**2024 SMP Package II (Lark St) Project**  
**Solicitation Number: CO-00666**  
**Job No.: 22-5040 & 22-5536**

**ADDENDUM 1**  
**August 17, 2023**

2024 SMP PACKAGE II ( LARK ST )  
WATER PLANS

2024 SMP PACKAGE II ( LARK ST ) SEWER PLANS
GENERAL NOTES AND SUMMARY OF QUANTITIES

MAP No(s).	DATE: 8/15/2023
SAWS JOB NO.: 22-5040	W3
DRWN BY: RM	DSGN BY: JI
CHKD BY: BJS

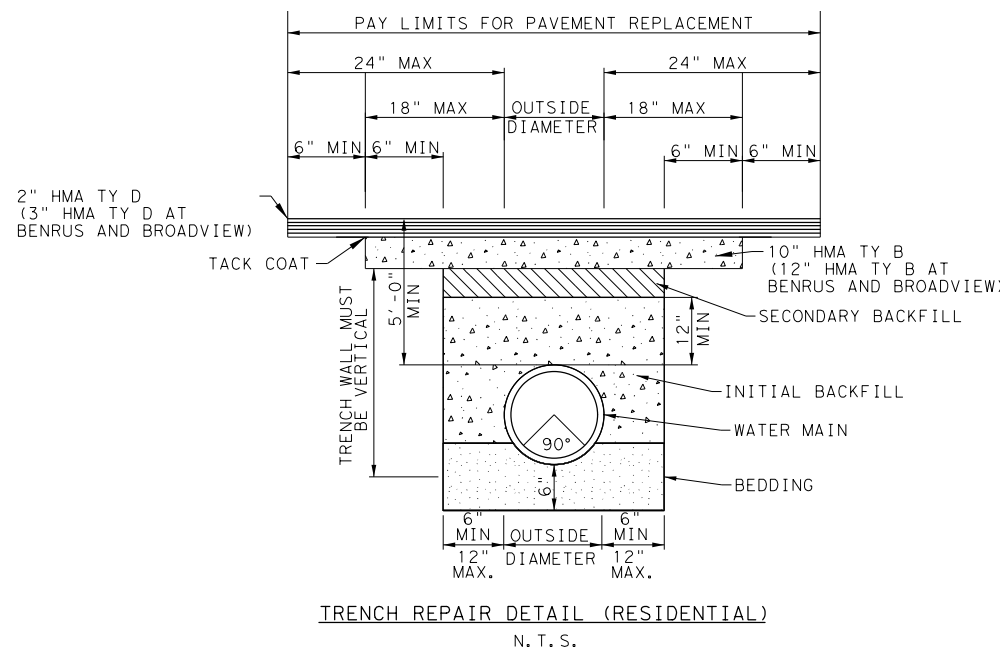
1. ***Remove and replace Page W3 to the water plans with the page dated 8/15/2023 as items for SAWS Specification 102, Intermediate Demobilization and Remobilization have been added.***
2. ***Remove and replace Page S2 to the sewer plans with the page dated 8/17/2023 as items for SAWS Specification 102, Intermediate Demobilization and Remobilization have been added.***

1	08/14/23	REVISED BY ADDENDUM #1	J1	BS
NO	DATE	DESCRIPTION	DWG	CHK
